## ADDENDUM NO. 1

From: ADDENDUM NO. 1 DCR Contract # P25-3582-C1A

### Notice of Modifications of PS&E Package

**WALTHAM**  
**MCR T WALTHAM LINDEN STREET BRIDGE**

**STRUCTURAL NOTES**

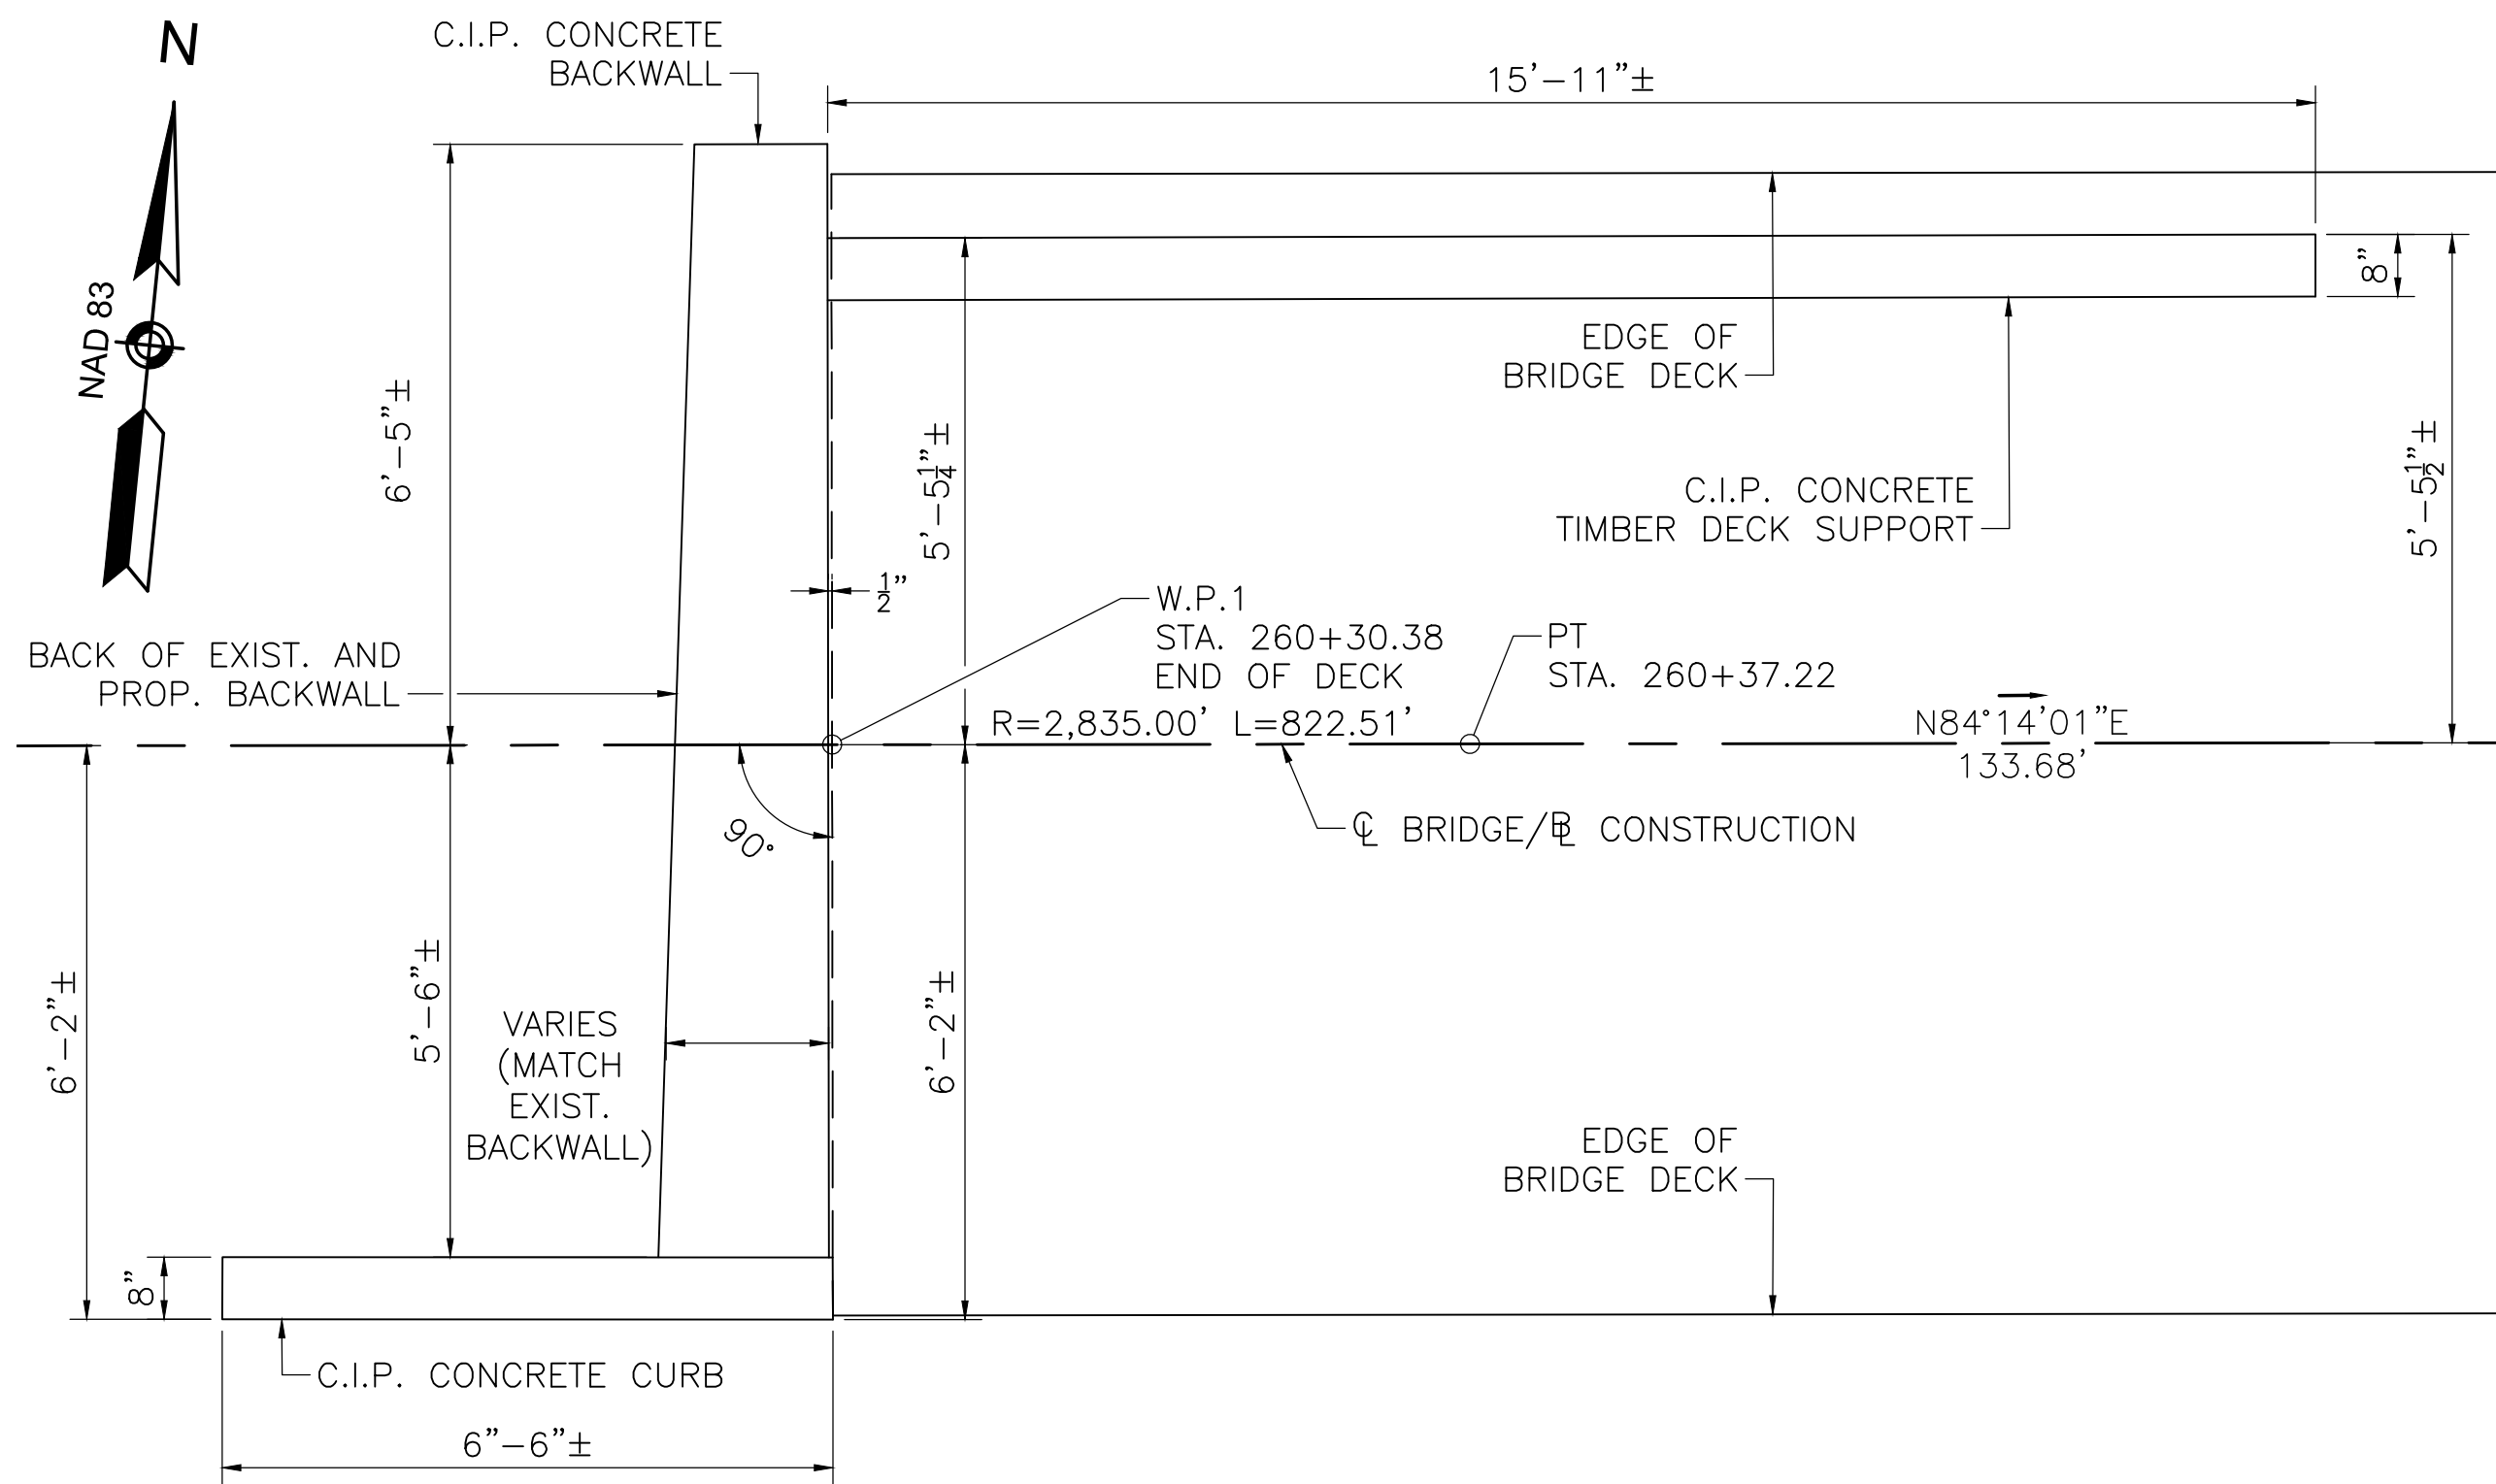
1. Plan Sheet 4 – The Split Rail Fence detail has been revised.
2. Plan Sheet 5 – An existing tree has been added to the plan east of the bridge.
3. Plan Sheet 9 – Structural Steel Notes 3 and 8 have been revised. Shielding Note 3 has been added. The bronze plaque dimensions have been revised.
4. Plan Sheet 11 – The gap dimension in the C.I.P Concrete Timber Deck Support Detail has been revised.
5. Plan Sheet 14 – The attachment detail callout in Rail Detail has been shifted.
6. Plan Sheet 15 – The split-rail fence has been modified to match the revised detail on Sheet 4. Some text has been adjusted for clarity but not otherwise modified.

The cleaning notes on Sheet 9 state that the existing bridge structure shall be cleaned of all loose debris and vegetation. Does that apply to the entire truss superstructure or only the areas below the deck level?

The structural steel notes on Sheet 9 include "All structural steel components and fastening hardware shall be hot-dipped galvanized and painted in accordance with the standard specifications. Paint shall be dark bronze". The documents do not call for the bridge to be painted. Please clarify the desired finish for the new steel components – plain steel, weathering steel, galvanized, painted...

Spec section 107.97 includes "All existing steel member surfaces that will be in permanent contact with new steel shall be cleaned to at least SSPC-SP3 and primed with an approved primer before performing the repairs." Is this step required since the bridge is not being painted?

Could you please verify method of payment for bridge shielding work?

The cleaning notes to the entire bridge superstructure.

All new steel components shall be treated as specified in Structural Steel Note 3 on Sheet 9 of 15. Existing steel shall not be coated except as required by Structural Steel Note 8 and Special Provision 107.97. This has been clarified by addendum.

This step is required. The primer shall be limited to surfaces to be in contact with new structural steel. Structural Steel Note 8 on Sheet 9 of 15 has been modified by addendum to match the Special Provision.

Shielding will not be measured or paid for separately. The shielding shall be considered incidental to the related items of work. A note has been added to Plan Sheet 9 by addendum.

Galvanizing and painting is required for new structural steel components per Structural Steel Note 3 on Plan Sheet 9. This requirement has been added to the Special Provision by addendum for clarity.

**ATTACHMENT DETAIL**  
SCALE: 1 1/2" = 1'-0"

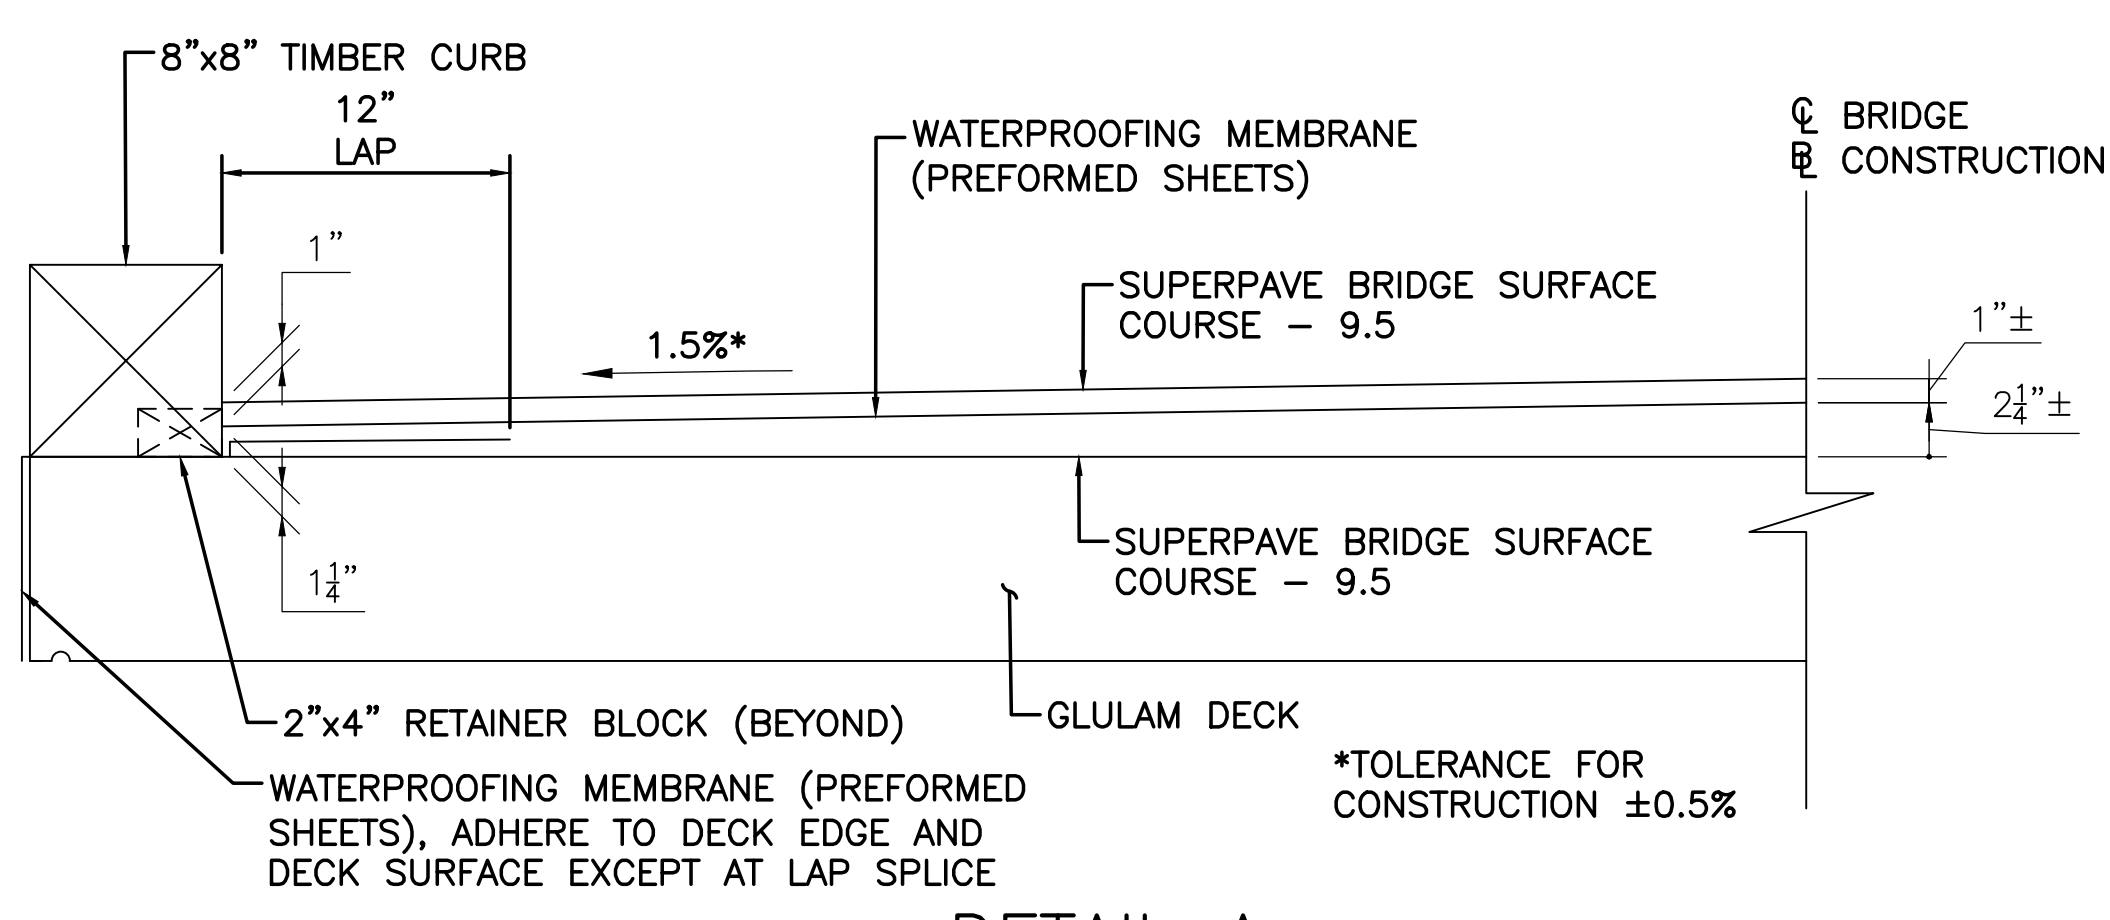
Does the curb and post "Attachment Detail", depicted on pg. 14 of 15 (project drawings), apply to every (bridge rail system) post location?

The attachment detail applies to all bridge rail post locations.

**DETAIL A**  
SCALE: 1 1/2" = 1'-0"

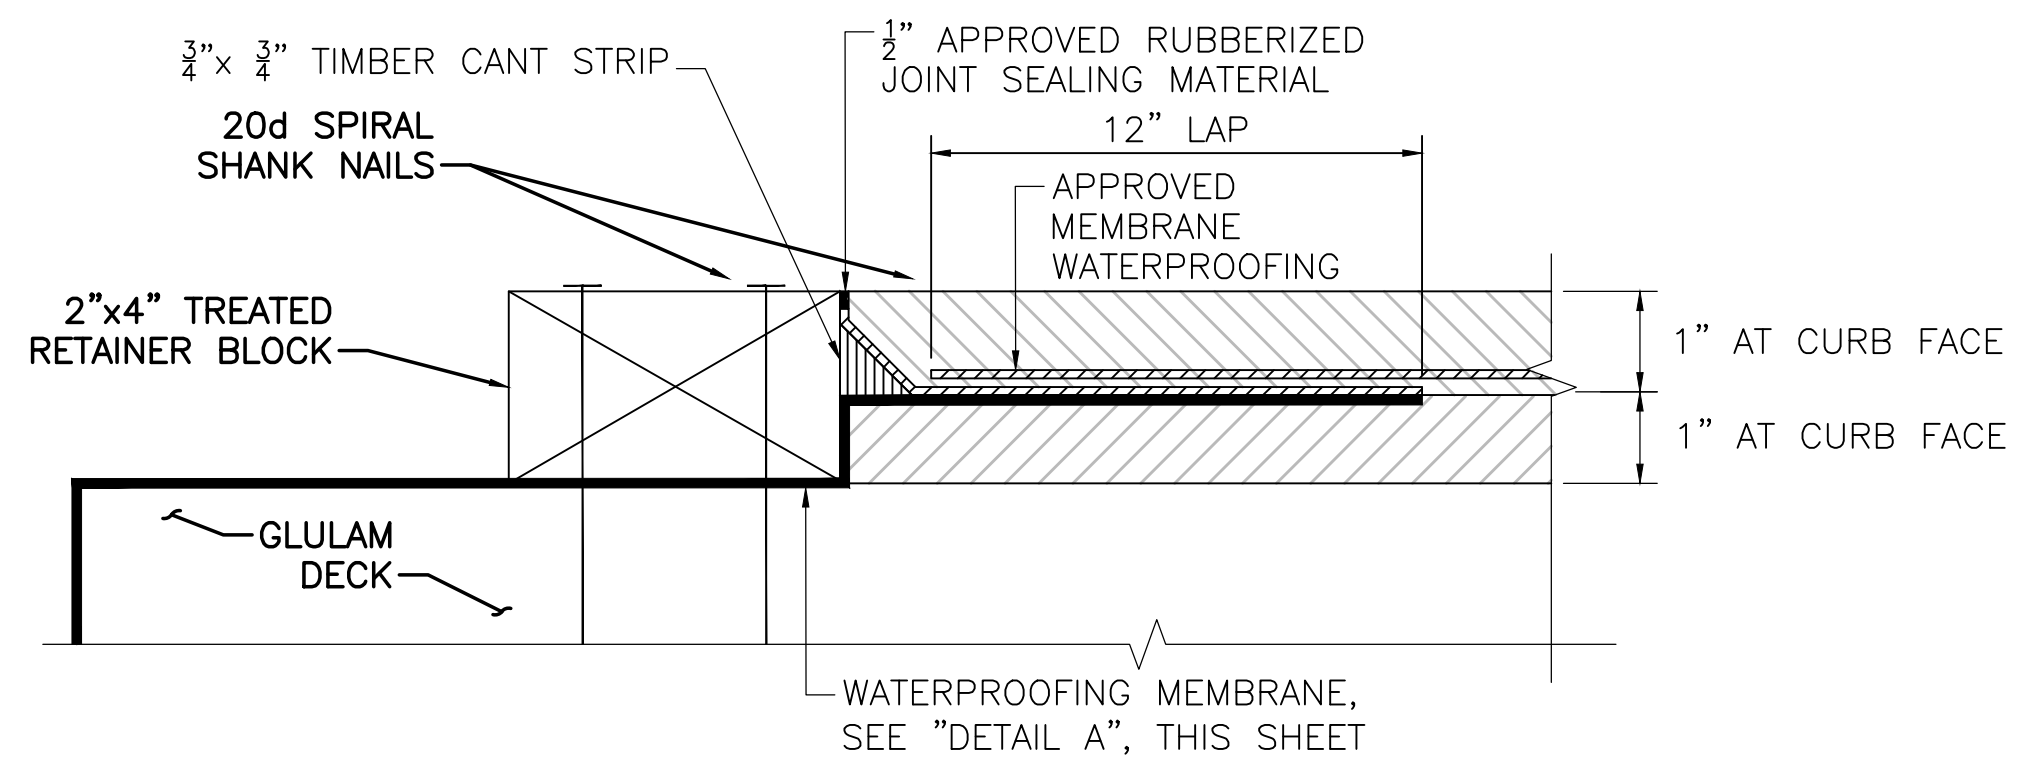
Drawing sheet 14 calls for the new bridge deck to receive two courses of SUPERPAVE Bridge Surface Course - 9.5. Will Pay Item 450.60 be added to the project or is the bridge paving incidental to Item 992.12?

Detail A on plan sheet #14 calls for two lifts of Superpave Bridge Surface Course – 9.5 on the bridge deck. There is no bridge pavement item within the contract, please advise.

The bridge pavement is incidental to Item 992.12. Special Provision 992.12 has been clarified by addendum, including adding a line to the Schedule for Partial Payment.

Special Provision 992.12 has been updated by Addendum to clarify that the bridge surface course is incidental to this item.
